Bulletin Ref: TB30a

Vauxhall

AAL1816

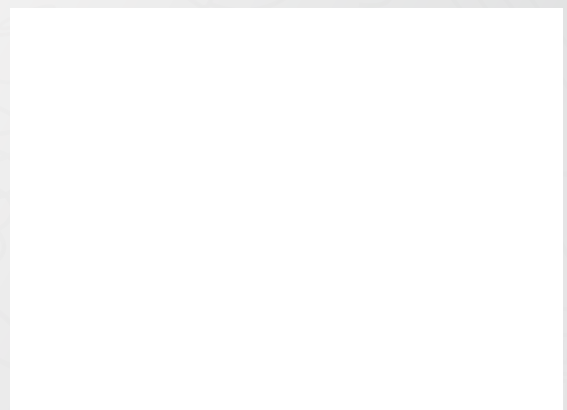
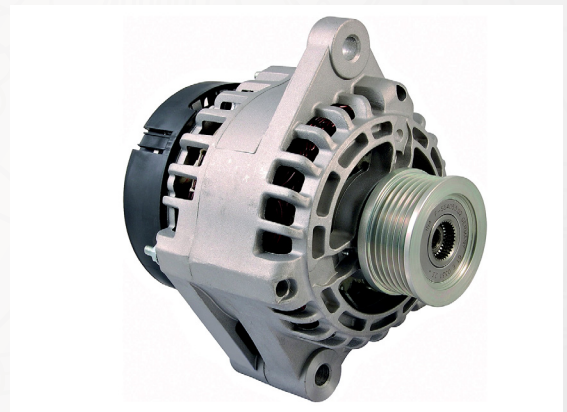
This is the earlier non 'smart charge' unit with stud fitting on the rear.

Vauxhall 1.9 CDTi models from 2007 use a 'smart charge' unit which has a 2 pin multiplug connector on the rear, these will not interchange.

Please double check before ordering.
